FIX FOR FAULTY FLASHING

New K-10 Relay

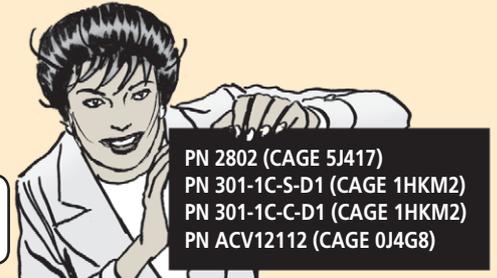
The culprit is the K-10 relay located in the passenger side power distribution panel (PDP). It doesn't operate correctly in that circuit, so the front turn signal lights flash.

A NEW REPLACEMENT RELAY IS AVAILABLE TO CORRECT THIS PROBLEM.

REPLACEMENT K-10 RELAYS ARE IDENTIFIED BY A BLUE MARKING ON TOP.

THESE RELAYS WILL ALSO HAVE ANY ONE OF THE FOLLOWING VENDOR PART NUMBERS STAMPED ON THEM...

- PN 2802 (CAGE 5J417)
- PN 301-1C-S-D1 (CAGE 1HKM2)
- PN 301-1C-C-D1 (CAGE 1HKM2)
- PN ACV12112 (CAGE 0J4G8)

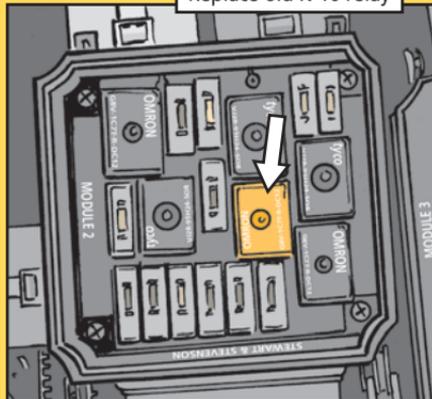
5. Remove the old K-10 relay, NSN 5945-01-527-6667 and PN G8V-1C7T-R-DC12, and replace it with the new relay, NSN 5945-01-557-4666 and PN 12424852. This relay location is referenced on the outside of the relay panel cover as K10/12V/ Stop/Hazard.

Replace old K-10 relay

Replacement K-10 relay will have blue marking on top
